Meeting Agenda

Historic Zoning Commission

Monday, September 11, 2023

Property Line (to be verified)

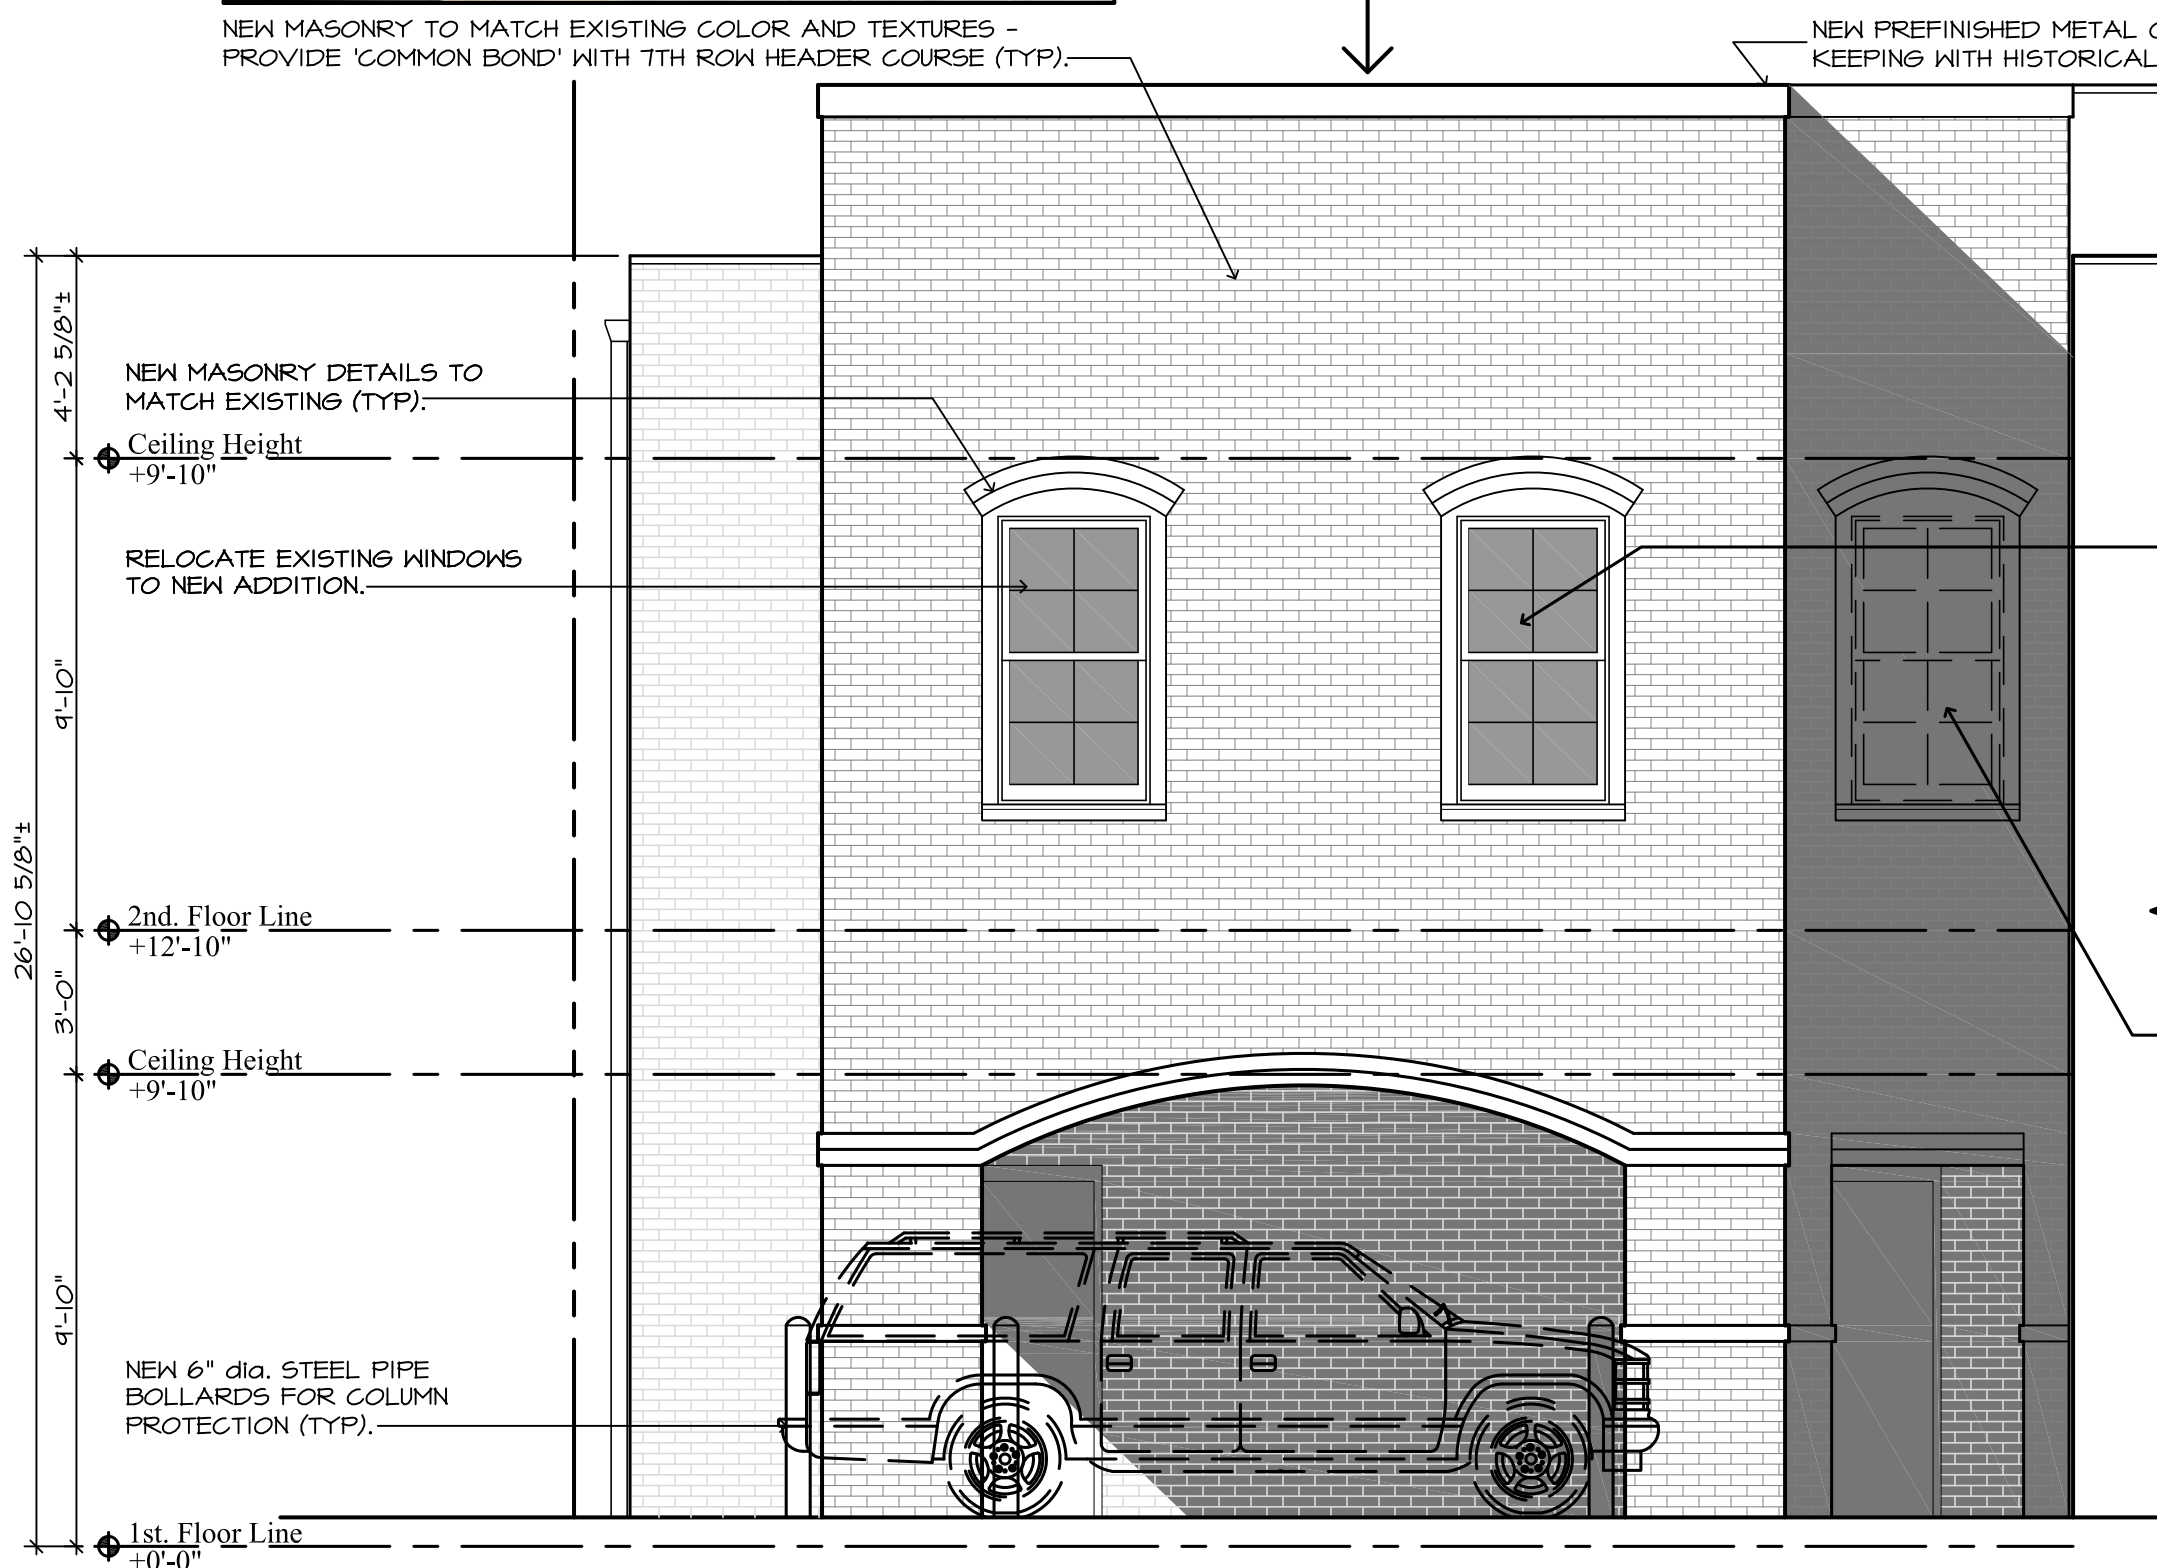
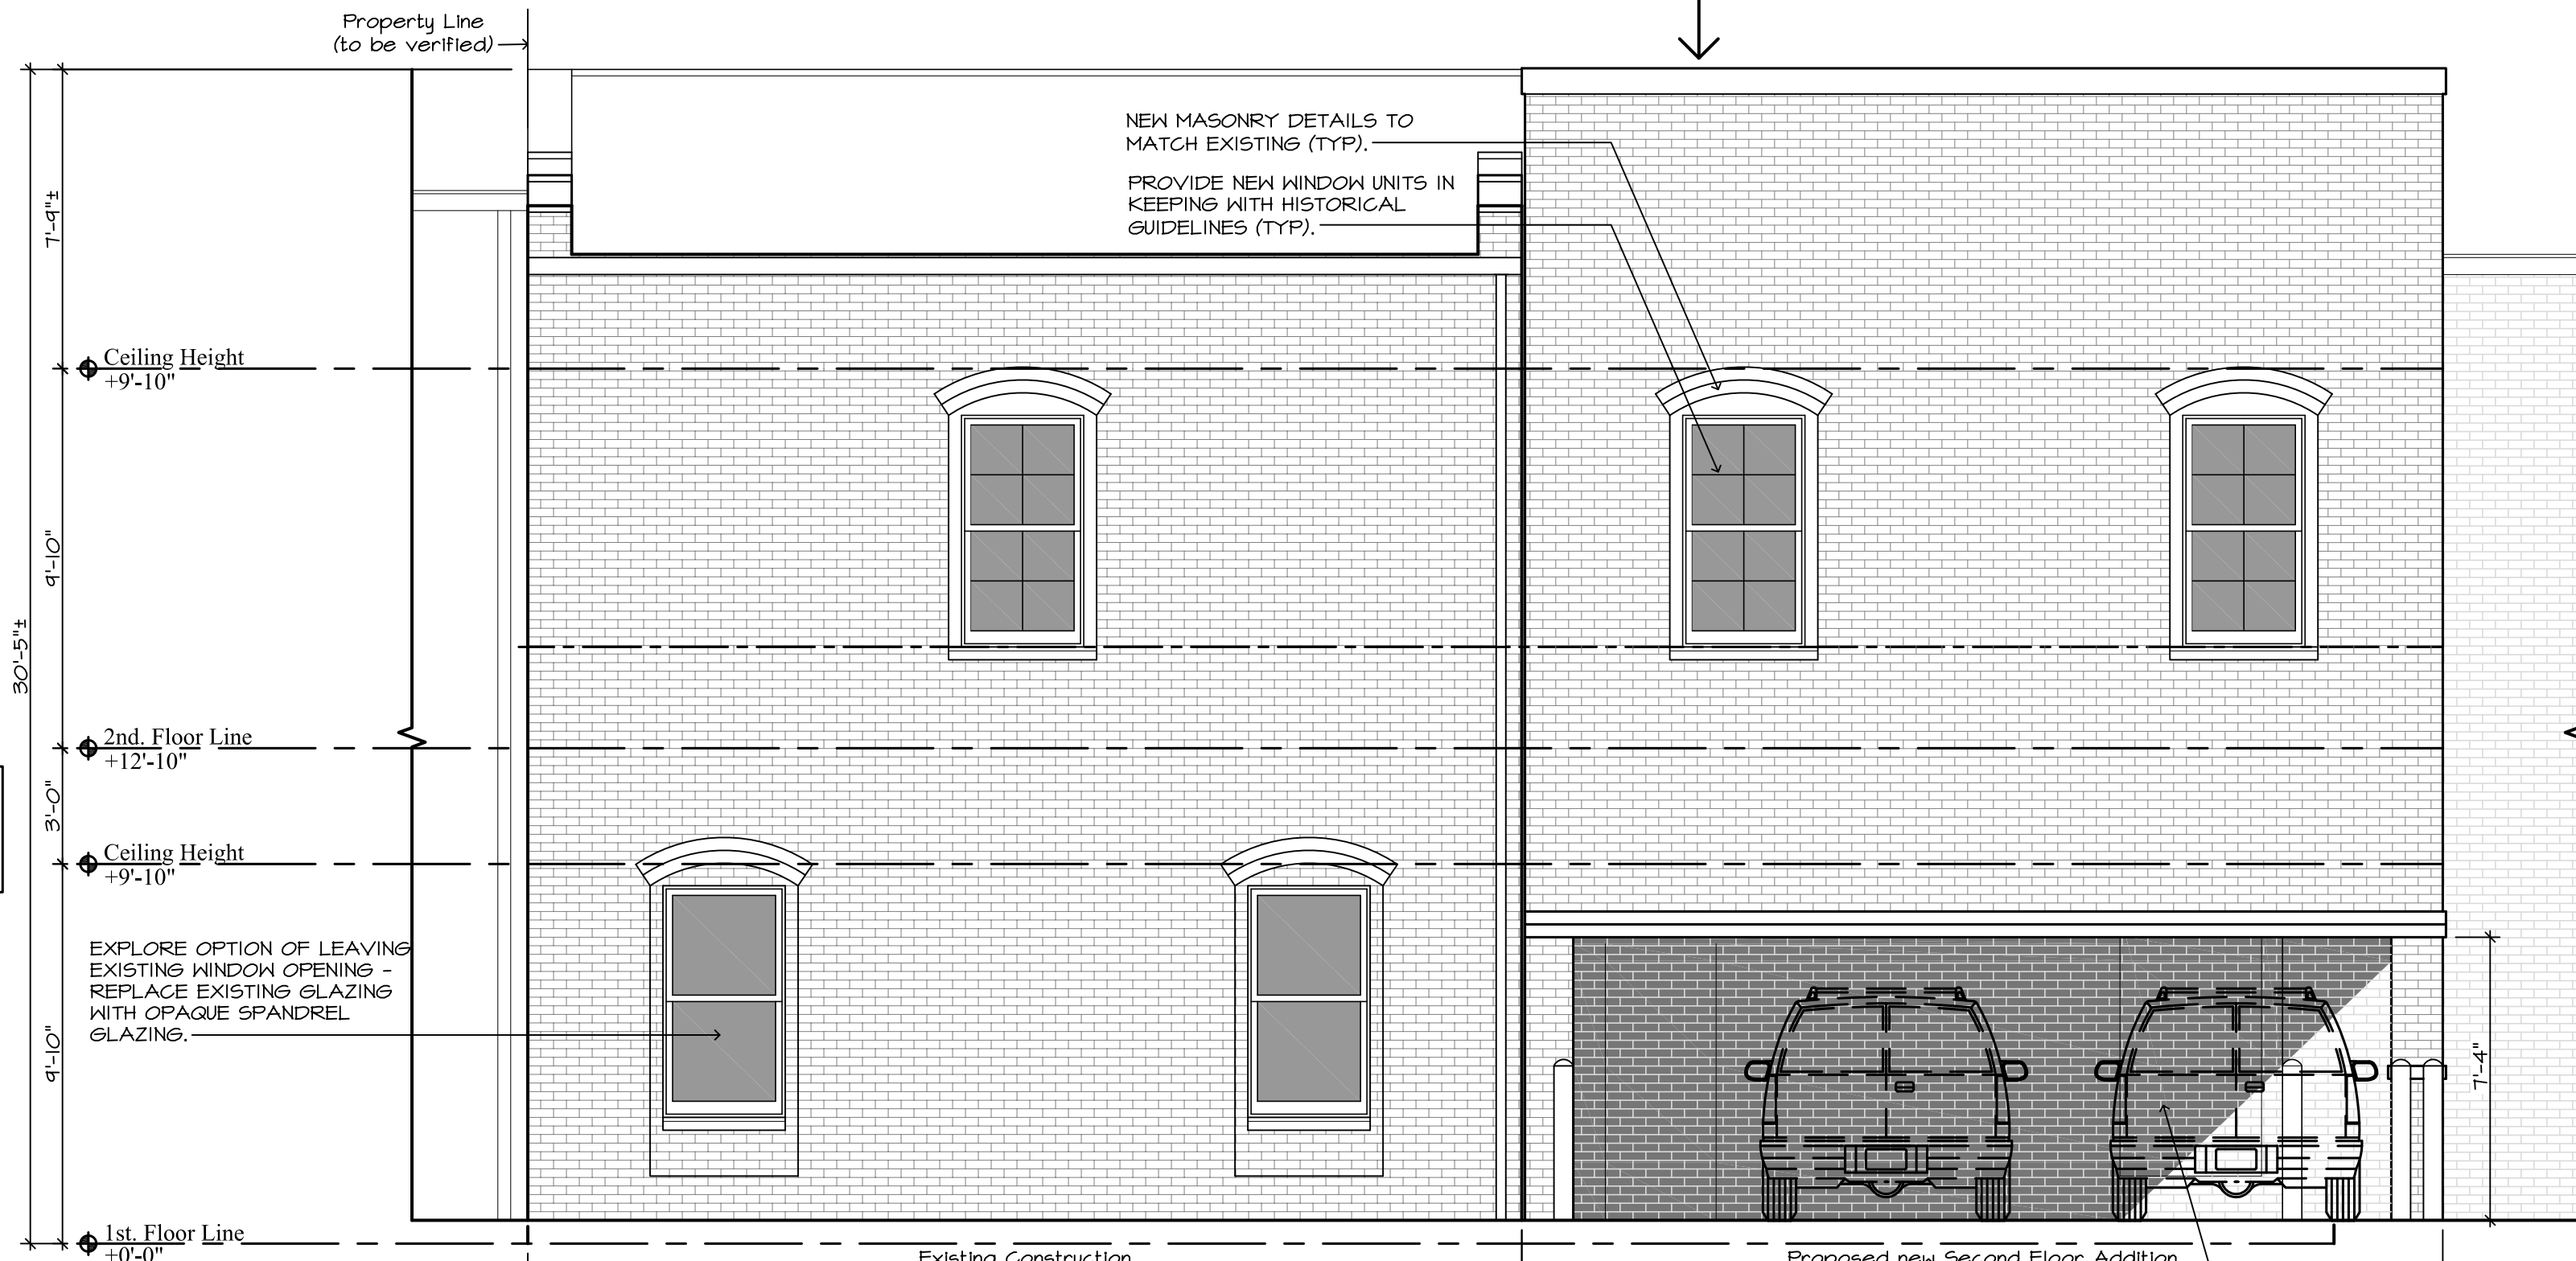
- Design additions to be subordinate in appearance to the historic building. Considerations include placement, size, massing, scale, height, setbacks, and materials.
- Avoid removal of sections of historic walls to accommodate additions unless significant structural deficiencies can be demonstrated. Design additions so that owners may remove the additions and restore the original facade if so desired.

Staff recommends denial of this application based on the following grounds:

1. Design additions to be subordinate in appearance to the historic building.
2. Avoid removal of sections of historic walls to accommodate additions unless significant structural deficiencies can be demonstrated.

1. The lots owned by the property owner must be consolidated prior to construction to be in compliance with the rear lot setback requirements.
2. The proposed brick and mortar shall match the historic brick, with a material sample of the brick and mortar subject to approval by the Preservation Planner or the Historic Zoning Commission.
3. The proposal for front door replacement shall be submitted as a separate COA application.
4. The application must meet all the requirements of the City of Franklin prior to issuance of a building permit.
5. Any additional changes to the approved plans must be returned to the Preservation Planner or the Historic Zoning Commission for review and approval.
